**DALLAS INDEPENDENT SCHOOL DISTRICT
PROCUREMENT SERVICES
ADDENDUM NO. 02**

SOLICITATION NUMBER AND TITLE CSP#207571 Alex W. Spence Talented and Gifted Preparatory

December 10, 2025

The Purpose of this Addendum No. 02 is to provide questions and answers received for the noted solicitation. In addition, there may also be updates to the solicitation which should be published as important information related to the process:

AD1.5

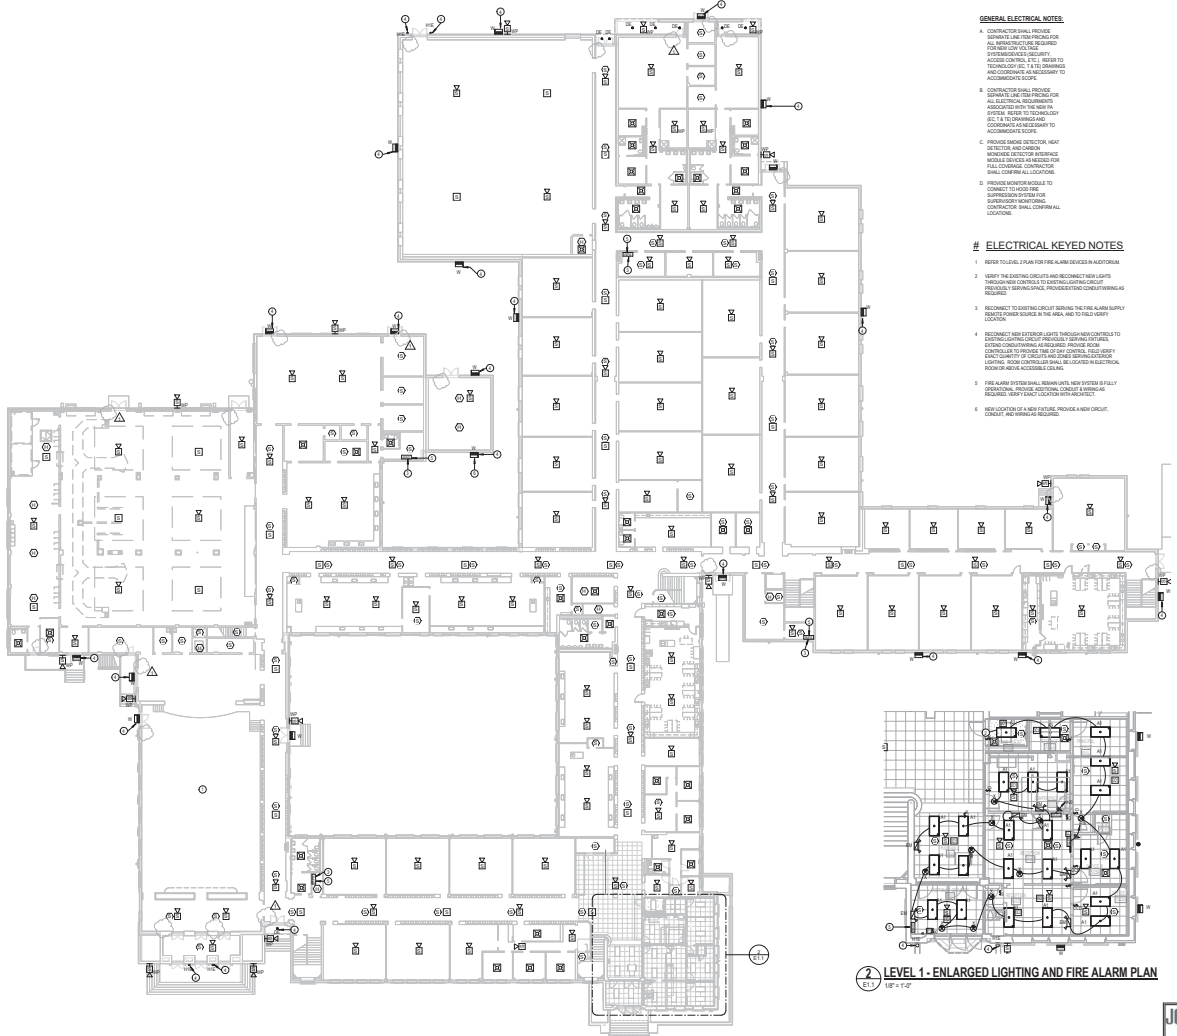
ITEM 11. SHEET AD1.5 – DEMO SECTION DETAILS & WINDOW TYPES: has been revised to provide additional notes and details related to window demolition and has been re-issued in its entirety.

GENERAL NOTE:
THIS WINDOW OPENING ORIGINALLY CONTAINED A STEEL CASEMENT WINDOW ASSEMBLY THAT HAS BEEN DEMO. AND REMOVED FOR THE CURRENTLY INSTALLED ALUMINUM FIXED WINDOW ASSEMBLY. S.C. IS TO FIELD VERIFY / CONFIRM IF ORIGINAL HEAD, JAMB AND SILL FRAME SECTIONS ARE STILL IN PLACE AND CAN BE USED FOR INSTALLATION OF THE NEW CASEMENT WINDOW ASSEMBLY.

- (1) S.C. TO DEMO. AND REMOVE ALL EXISTING GLAZING, ALUMIN. FIXED WINDOW ASSEMBLY, AS REQUIRED FOR INSTALLATION NEW FIXED GALV. / PAINTED STEEL CASEMENT WINDOW ASSEMBLY.
- (2) S.C. TO PROVIDE AND INSTALL A NEW FIXED GALV. & PAINTED STEEL WEATHER TIGHT CASEMENT WINDOW ASSEMBLY (FRAME, GLAZING, GLAZING FLOOF / SEALANT, FASTENERS AND ALL ASSOCIATED COMPONENTS) TO MATCH EXISTING BUILDING STEEL CASEMENT WINDOWS. REFER TO WINDOW ELEVATIONS AND DETAILS FOR ADDITIONAL INFO.
